INEL-95/0375

August 1995

**Evaluation of Sequoyah Nuclear Plant  
Offsite Dose Calculation Manual, Revision 28**

**Docket No. 50-327, Facility License No. DPR-77  
Docket No. 50-328, Facility License No. DPR-79**

Figure 1. Liquid effluent release routes at SQN. (Based on Figure 6.1 of the SQN ODCM Revision 28.)

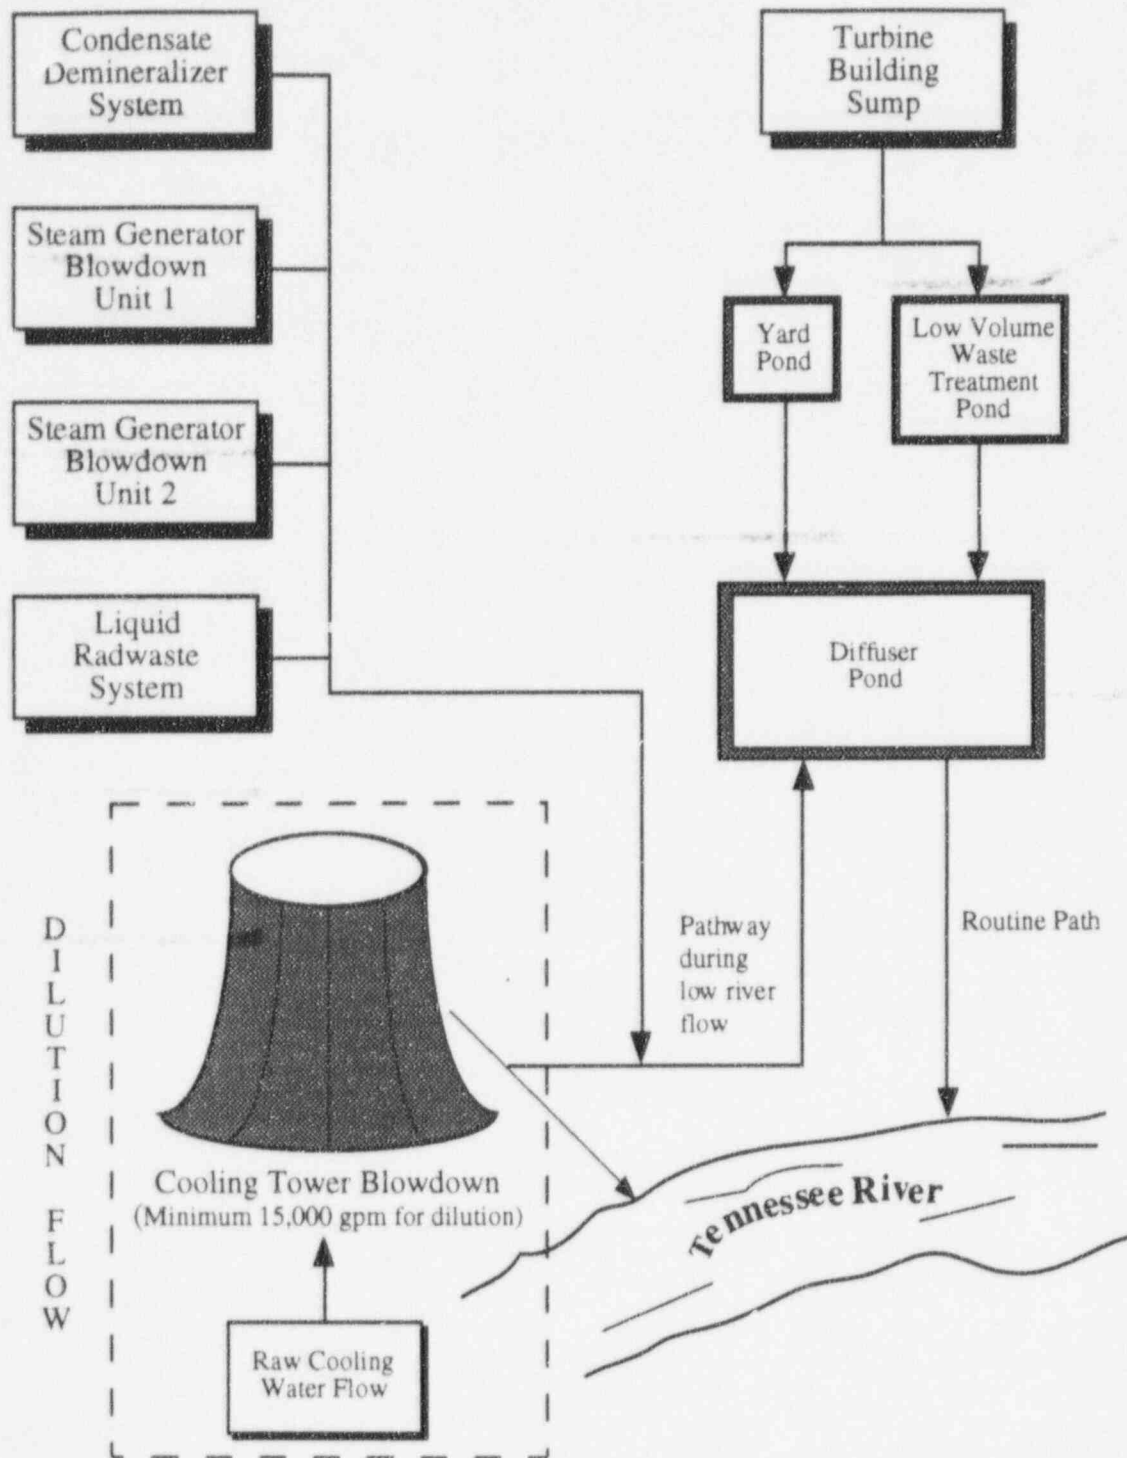
The methodologies listed in ODCM Section 6, Liquid Releases, to calculate setpoints are generally correct. However, it should be noted that the flowrates on page 64 for the tanks in the condensate demineralizer system are different than those specified in Figure 6.1. This discrepancy should be addressed. Specific comments are stated below:

- ODCM Figure 6.1, Liquid Effluent Release Points, should be simplified. An example of the possible simplification is illustrated in Figure 1 of this report of Sequoyah 1/2 ODCM. If more detail is desired by the licensee, use a separate figure for each major radioactive gaseous release point. Figures 2 and 3 of the Technical Review of Sequoyah 1/2 ODCM illustrate breaking up ODCM Figure 6.1 into several simpler illustrations.

Figure 2. Liquid radwaste system at SQN. (Based on Figure 6.2 of the SQN ODCM Revision 28.)

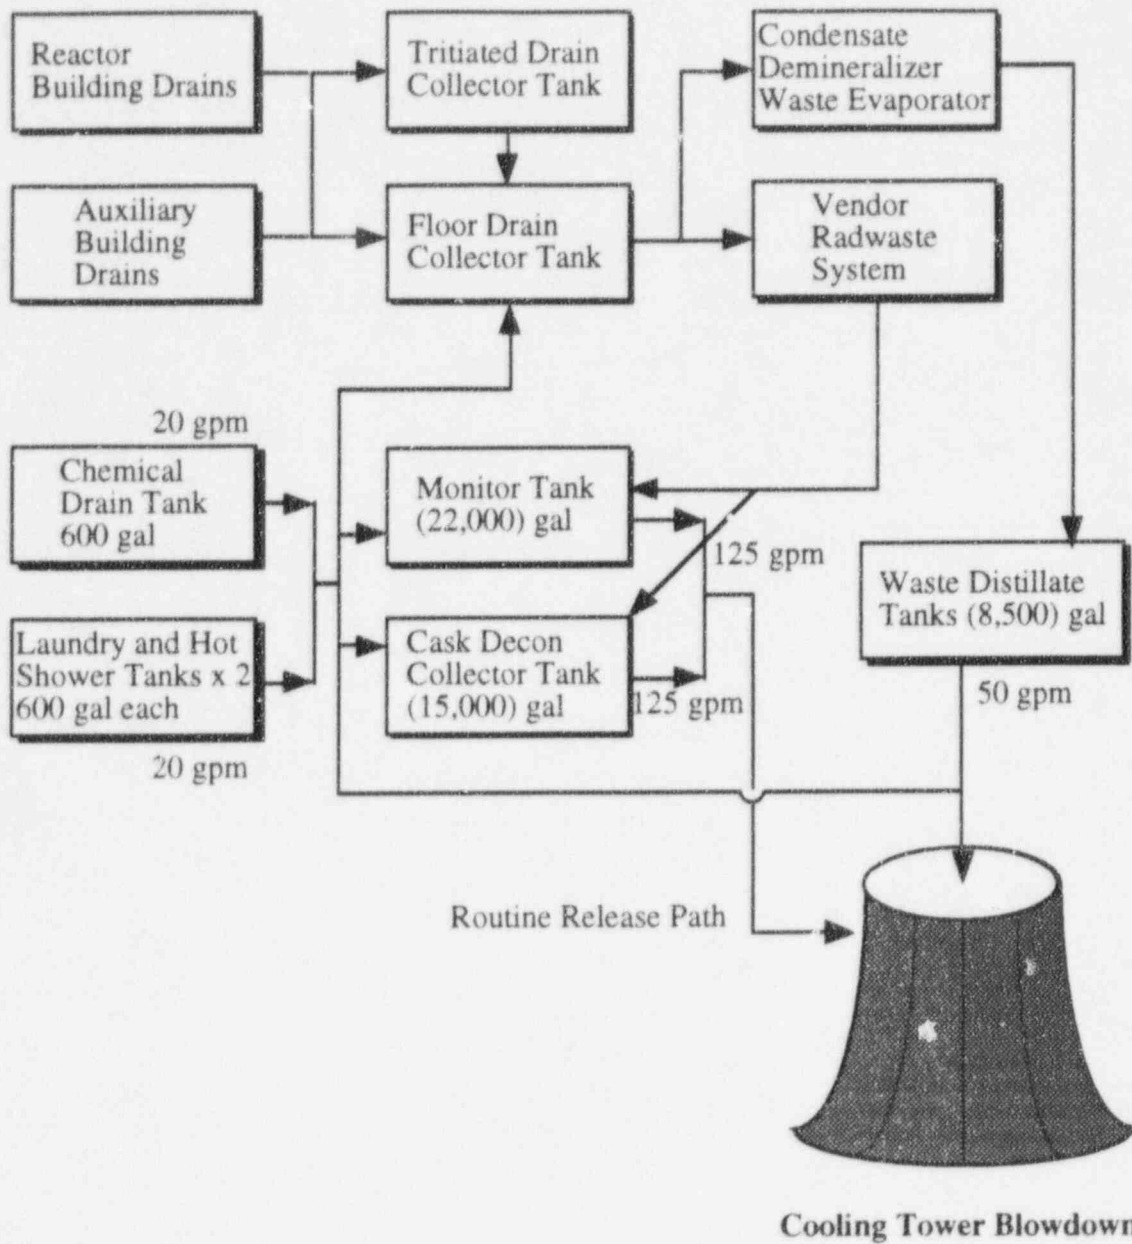
It is important to note that a complete listing of monitors and samplers is not included in Table 1.1-1. O-RM-90-211, which monitors the inlet to the diffuser pond, is not listed in Table 1.1-1 or ODCM Figure 6.1 and there is no required operability requirement. This monitor should monitor the cooling tower blowdown discharge. Further, there is no evidence of a monitor on the diffuser pond outlet, which would monitor possible concentration factors in the diffuser pond. Also, it is recommended that the flow rates for each liquid discharge point be included in a figure or tabular form. Table 2 lists the flow rates and storage capacity of tanks for five effluent liquid pathways. In ODCM Figure 6.1, a reference is made to ODCM Figure 2.2; it should refer to ODCM Figure 6.2.

**Figure 4.** Gaseous effluent release routes at SQN (based on Figure 7.1 of the SQN ODCM Revision 28.)

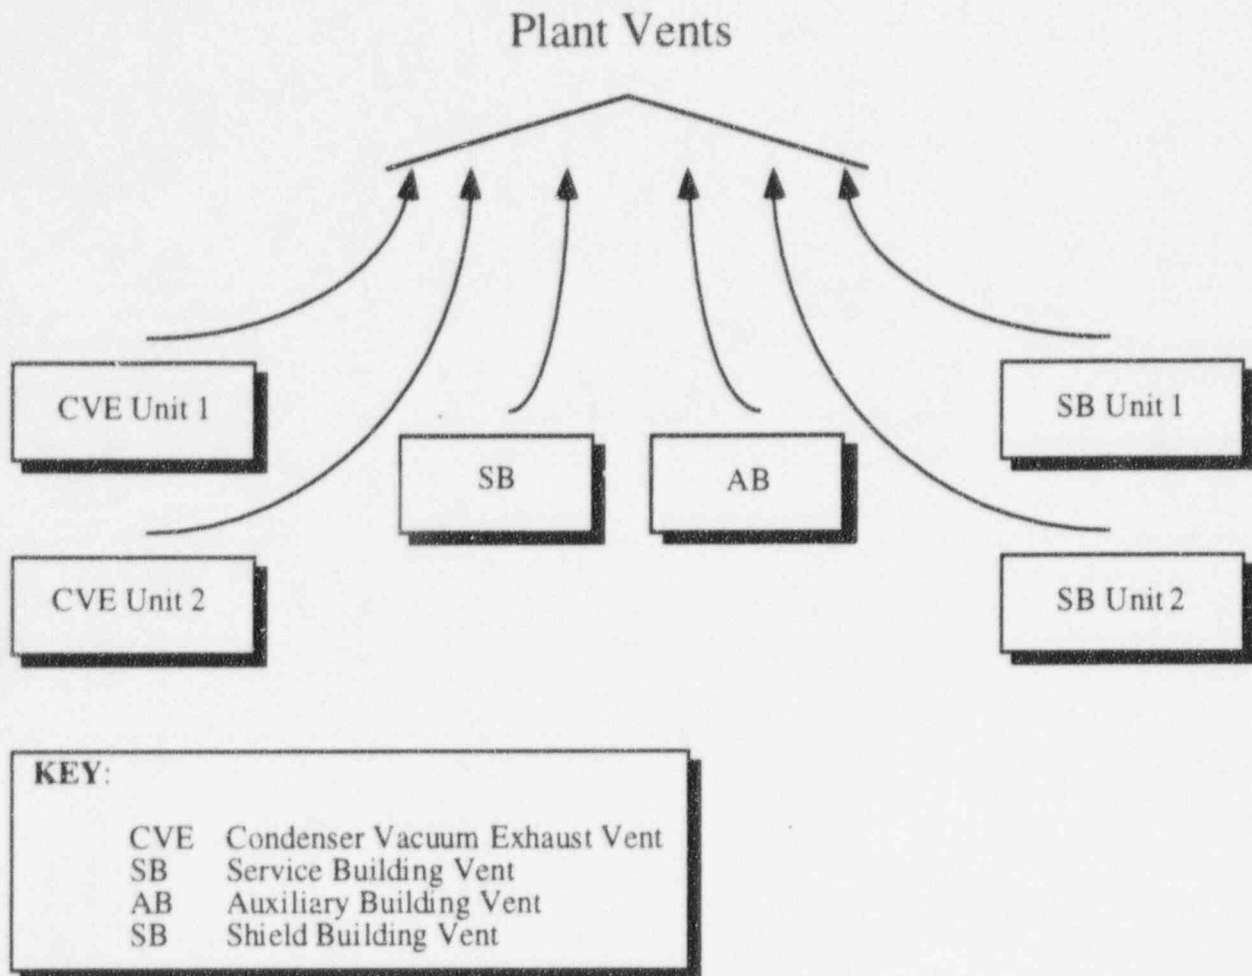
- ODCM Figure 7.1, "Gaseous Effluent Release Points," should be simplified. Add a symbol/term key. An example of the possible simplification is illustrated in Figure 4 of the Technical Review of Sequoyah 1/2 ODCM. If more detail is desired by the licensee, use a separate figure for each major radioactive gaseous release point.

**Figure 5.** Gaseous radwaste and off-gas treatment system at SQN. (Based on Figure 7.3 of the SQN ODCM Revision 28.)

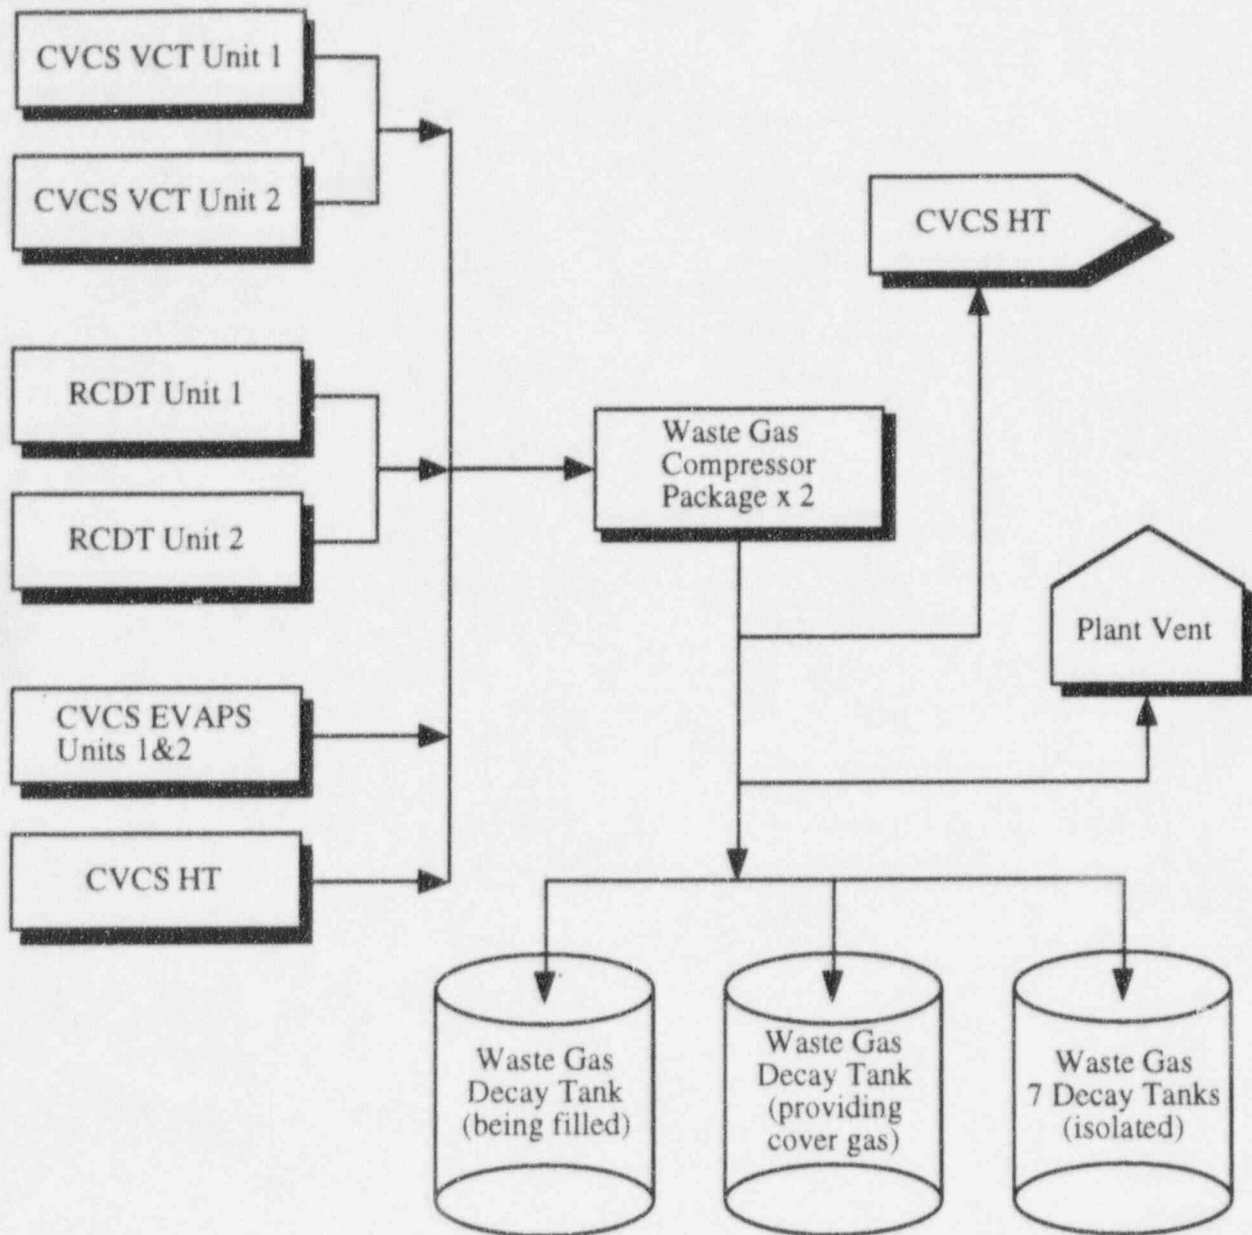
- ODCM Figure 7.3, "Gaseous Radwaste Treatment System," should be simplified. Add a symbol/term key. An example of the possible simplification is illustrated in Figure 5 of the Technical Review of Sequoyah 1/2 ODCM. If more detail is desired by the licensee, use a separate figure for each major radioactive gaseous release point.
